1. Type of Well S Oil Well Gas Well Ot						14 FEDERAL 4H
2. Name of Operator DEVON ENERGY PRODUCT	Contact: FION CO EPMail: trina.coucl	TRINA C COUCH h@dvn.com			9. API Well No. 30-015-42505-(	00-X1
3a. Address 333 WEST SHERIDAN AVE OKLAHOMA CITY, OK 7310	2	3b. Phone No. (incl Ph: 405-228-72			10. Field and Pool, or COTTON DRA	Exploratory W

3. Well head change - use a n	nulti-bowl wellhead	NAR -		SEE A	TTACHED	FOR IFIC.
		ADT CO	NSE	CONE	DITIONS OF	APPROVAL
Please see the following attac Drilling Plan Revision Directional Survey Revision	hments:	NIM OIL CO ARTESIA NOV 1	NSERVAT	TION		
		D				······
<ol> <li>I hereby certify that the foregoing is Com</li> </ol>	true and correct. Electronic Submission #2 For DEVON ENERG nitted to AFMSS for proces	AY PRODUCTION CO	DLP, sent to	o the Carlsba	ud .	
Name(Printed/Typed) TRINA C (	COUCH	Title	REGULA	TORY ANA	LYST	
Signature (Electronic S	ubmission)	Date	11/03/20	14 AP	PROVED	
	THIS SPACE FC	R FEDERAL OF	STATE	FICE US	E	THE
pproved By	·				IV 5704	THEFE
nditions of approval, if any, are attached tify that the applicant holds legal or equich would entitle the applicant to condu-	itable title to those rights in the		e	BUREAU C	OF LAVY MANAGE

13 3/8 X 9 5/8

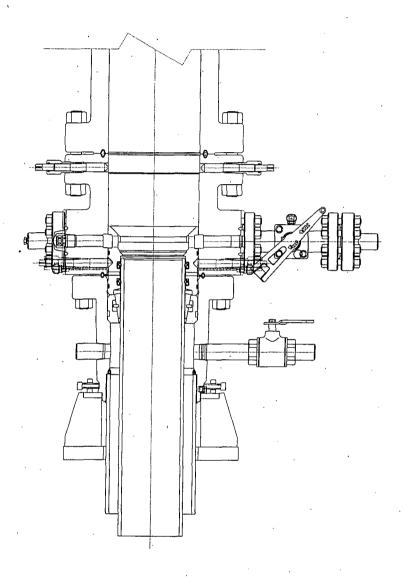
Devon proposes using a multi-bowl wellhead assembly (FMC Uni-head). This assembly will only be tested when installed on the surface casing. Minimum working pressure of the blowout preventer (BOP) and related equipment (BOPE) required for drilling below the surface casing shoe shall be 3000 (3M) psi.

- Wellhead will be installed by FMC's representatives.
- If the welding is performed by a third party, the FMC's representative will monitor the temperature to verify that it does not exceed the maximum temperature of the seal.

- FMC representative will install the test plug for the initial BOP test.
- FMC will install a solid steel body pack-off to completely isolate the lower head after cementing intermediate casing. After installation of the pack-off, the pack-off and the lower flange will be tested to 5M, as shown on the attached schematic. Everything above the pack-off will not have been altered whatsoever from the initial nipple up. Therefore the BOP components will not be retested at that time.

- 3. Operator has proposed a multi-bowl wellhead assembly. This assembly will only be tested when installed on the surface casing. Minimum working pressure of the blowout preventer (BOP) and related equipment (BOPE) required for drilling below the surface casing shoe shall be 3000 (3M) psi.

- a. Wellhead shall be installed by manufacturer's representatives, submit documentation with subsequent sundry.
  - b. If the welding is performed by a third party, the manufacturer's representative shall monitor the temperature to verify that it does not exceed the maximum temperature of the seal.

- c. Manufacturer representative shall install the test plug for the initial BOP test.
  - d. Operator shall perform the intermediate casing integrity test to 70% of the casing burst. This will test the multi-bowl seals.

- e. If the cement does not circulate and one inch operations would have been possible with a standard wellhead, the well head shall be cut off, cementing operations performed and another wellhead installed.
